SESA SOLAR AND ENERGY STORAGE  
ASSOCIATION  
OF PUERTO RICO

**RE: SESA Comments on and Redline of LUMA's Technical Interconnection Requirements (TIR) Proposal document in docket NEPR-MI-2019-0009**

To illustrate our recommendations, we include our redline of LUMA's November 1<sup>st</sup> 2022 filing. This latest LUMA filing was a redline of their proposed Technical Interconnection Requirements (TIR) and a redline of prior proposed rule revisions.

Figure 0-2. Example Volt-Watt characteristics

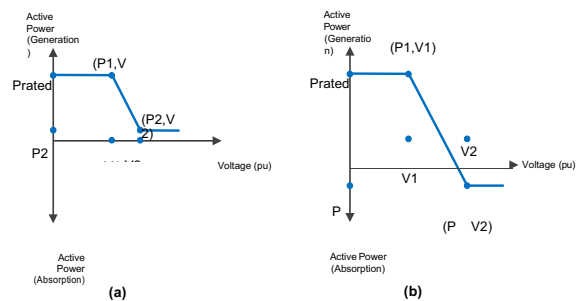
**Page 138-** Delete word “Activated” in regards Voltage – Active Power (Volt/Watt). Specific Comments by SESA regarding Voltage – Active Power (Volt/Watt): Deactivated or under mutual consent. Will be activated in future following PREB approval of consumer protection framework.
